January 13, 2015

Re: Design Progression – Final UDC
3204 Golden Copper Lane
Maple Grove Commons
Madison, WI
KBA Project #1355

Re: Letter of Intent – Final UDC Application
Maple Grove Commons
Madison, WI
KBA Project # 1355

1 FIRST FLOOR PLAN BUILDING A
A-1.1A 1/8"=1'-0"

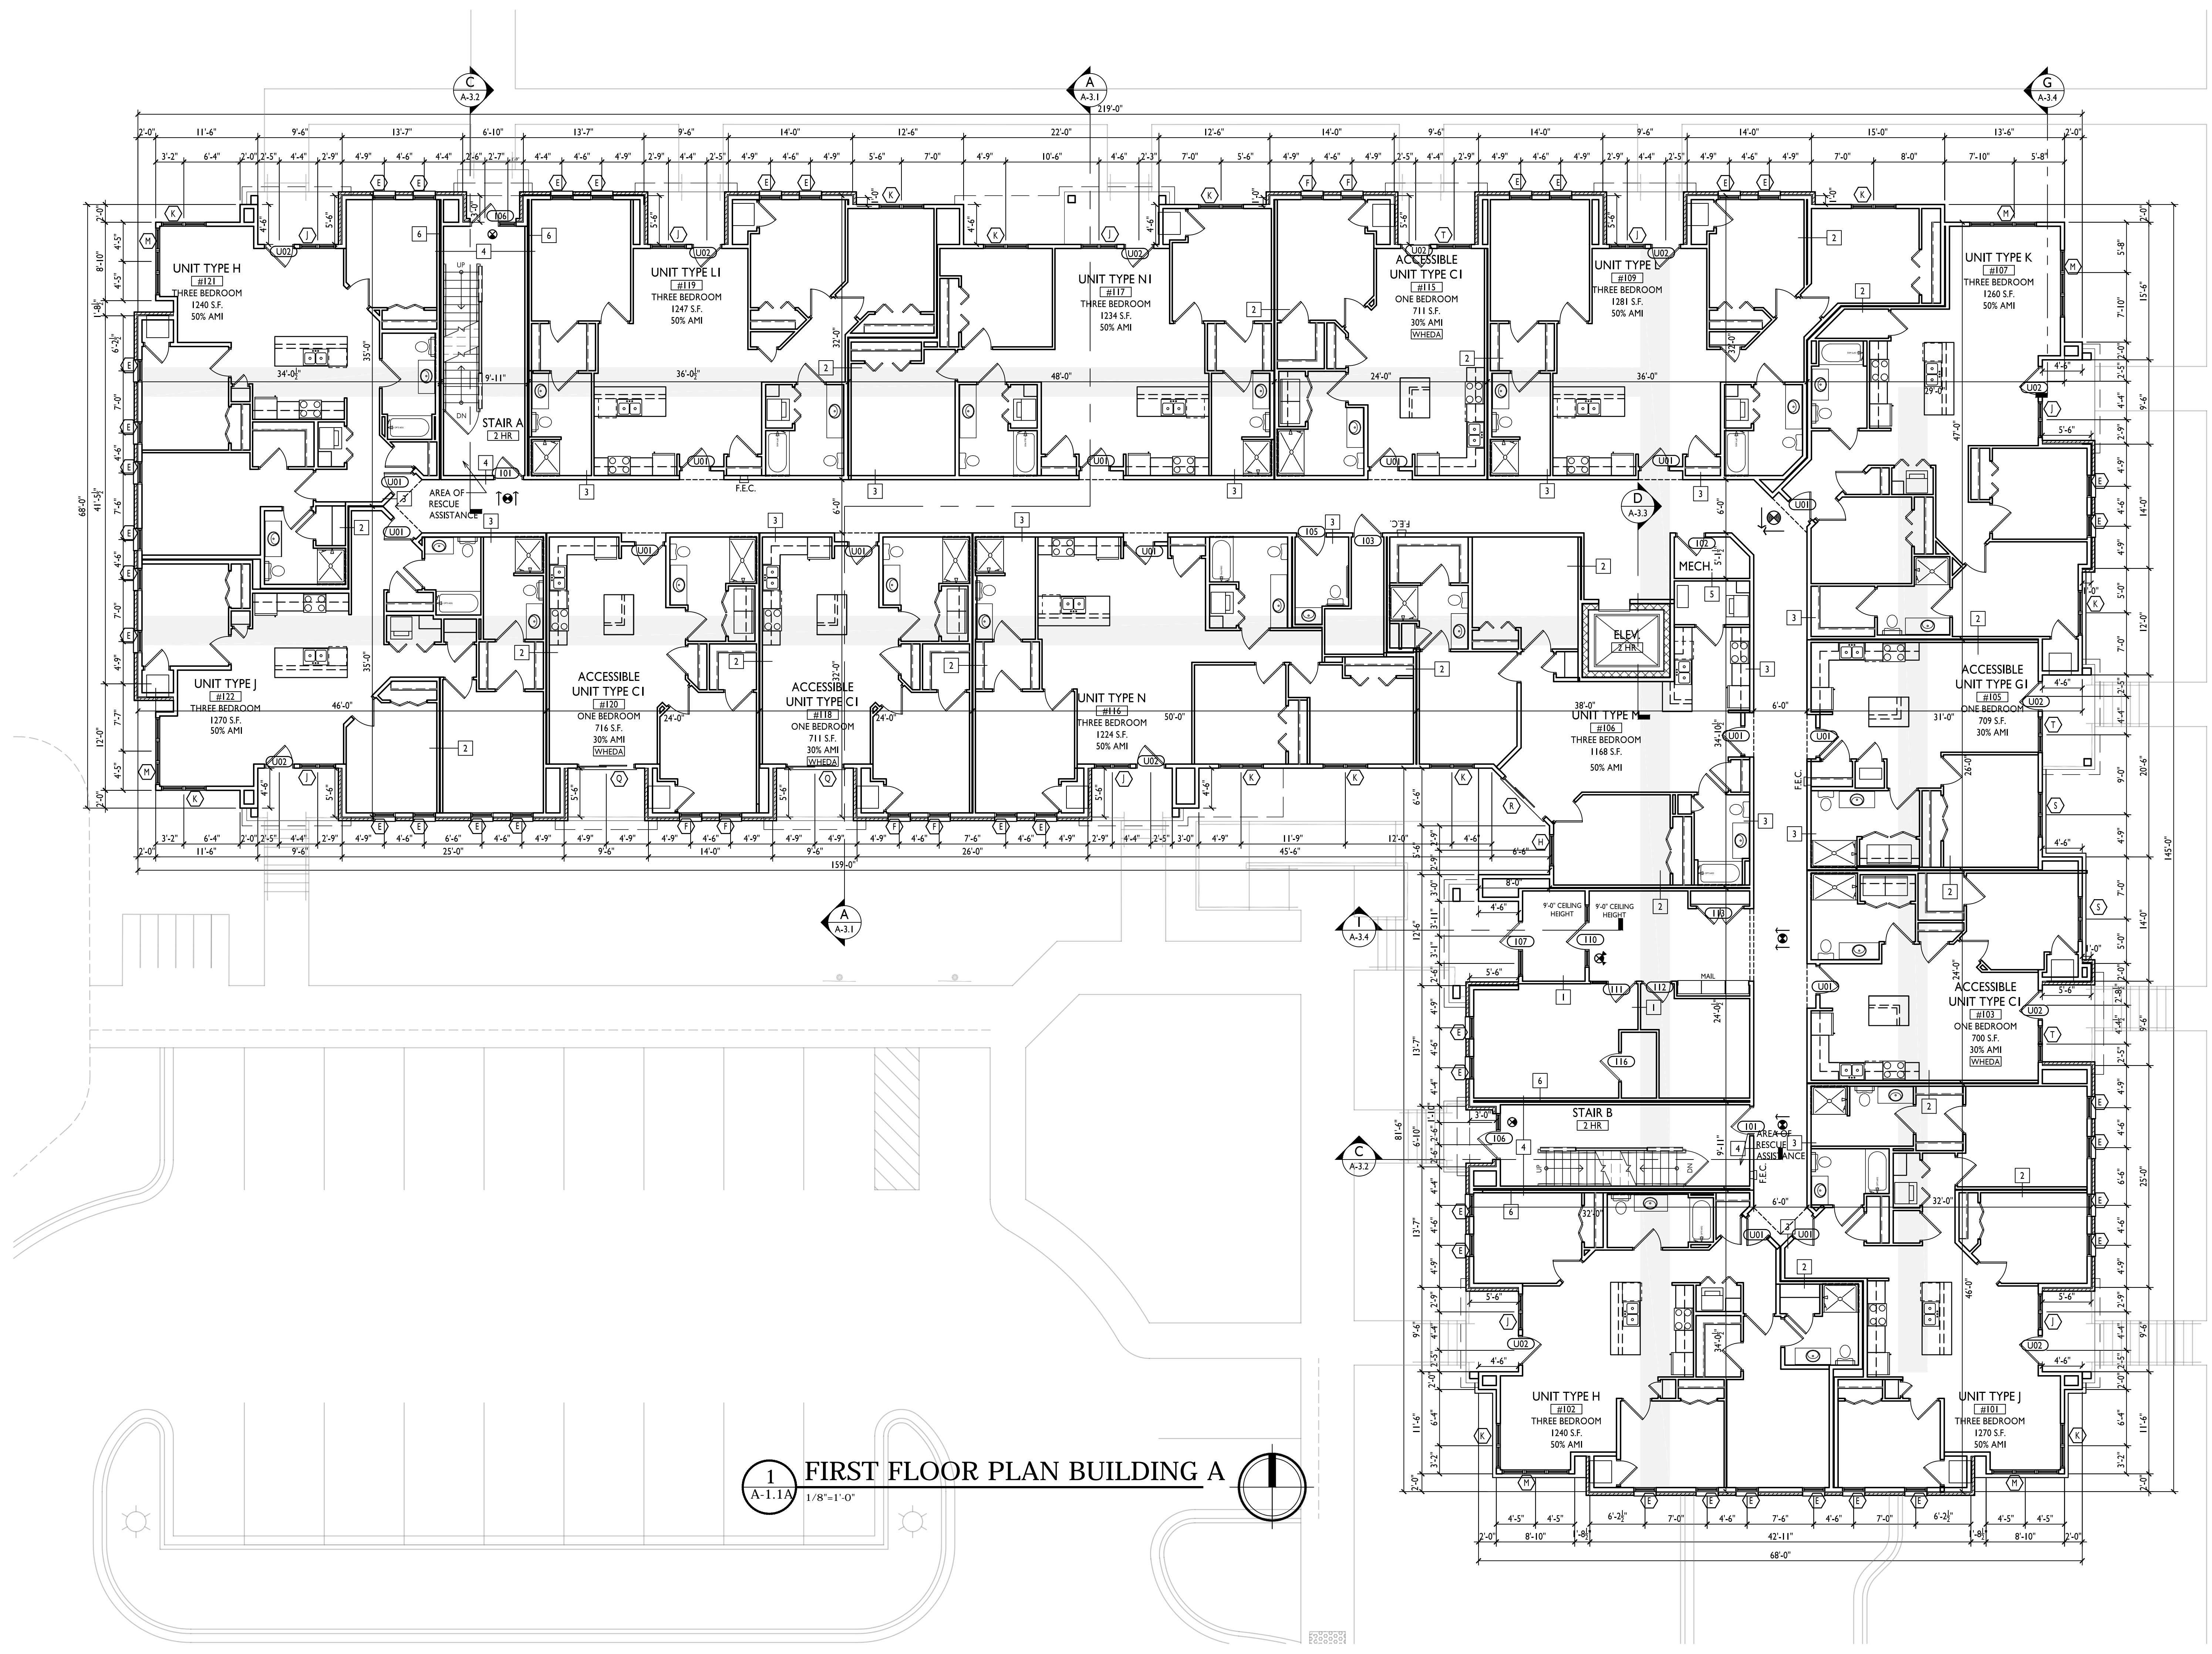
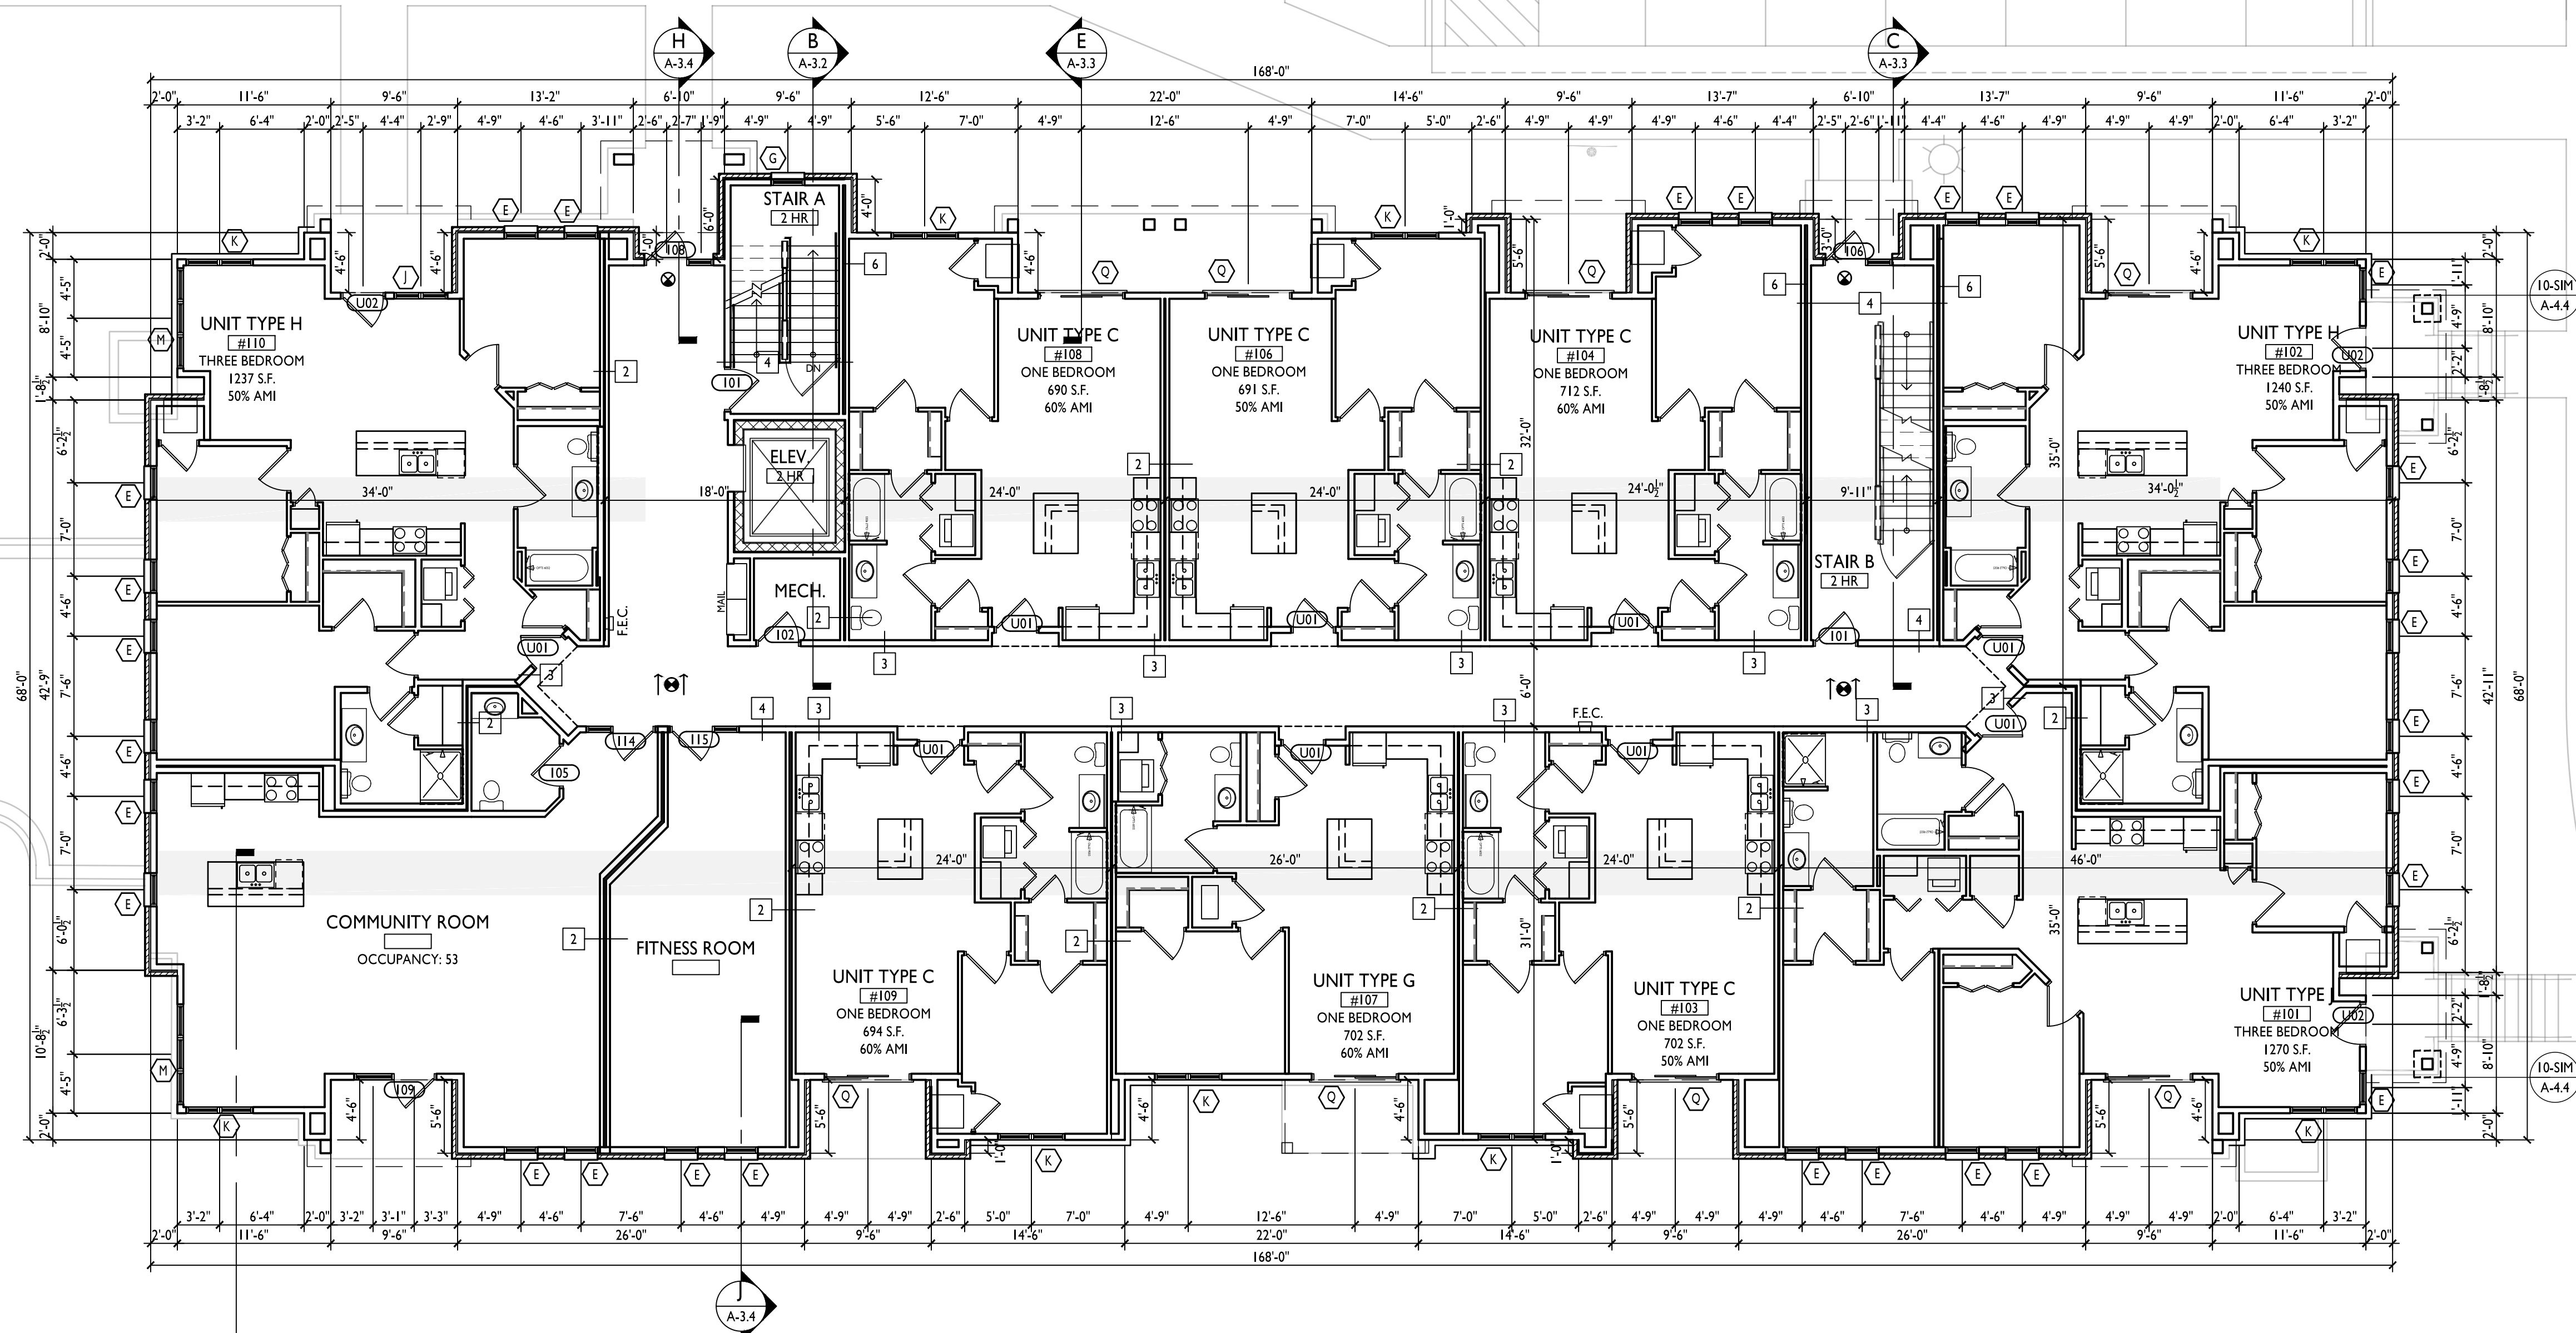
- HVAC units have been relocated in plan.

3204 & 3228 Golder
Copper Ln.
Madison, WI
SHEET TITLE
**Second Floor Plan
Building B**

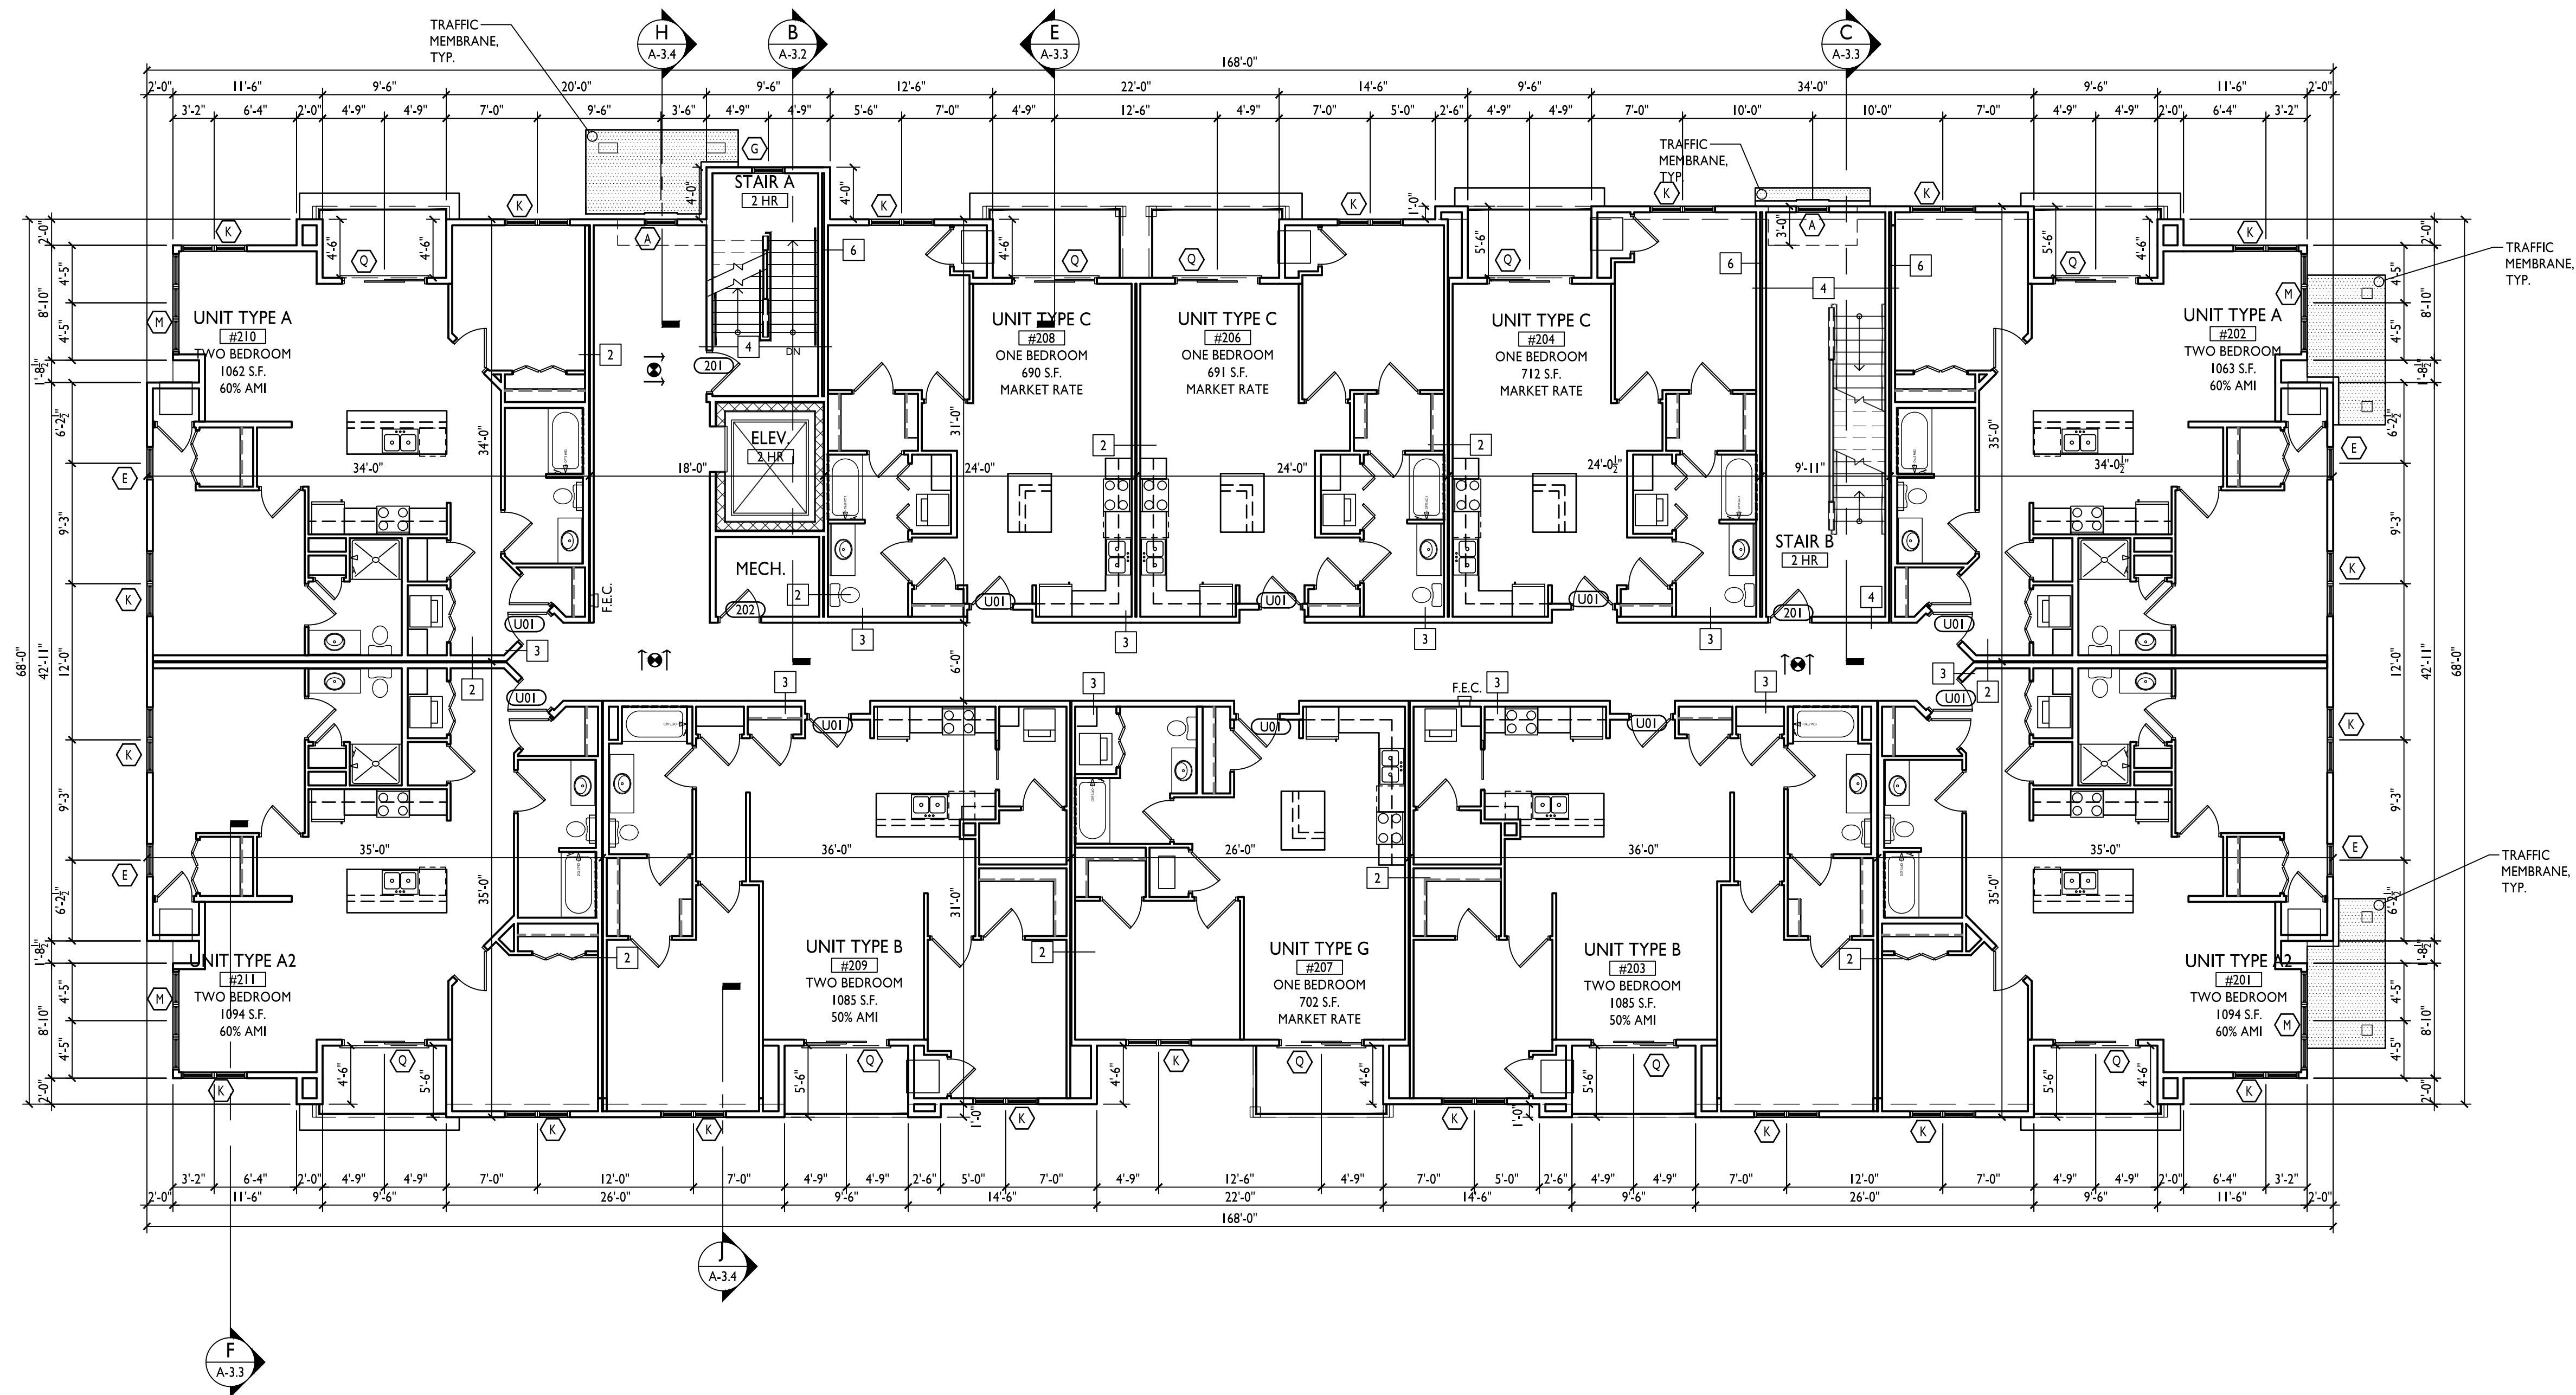
- Window patterns have been modified to match the window patterns on the third floor.
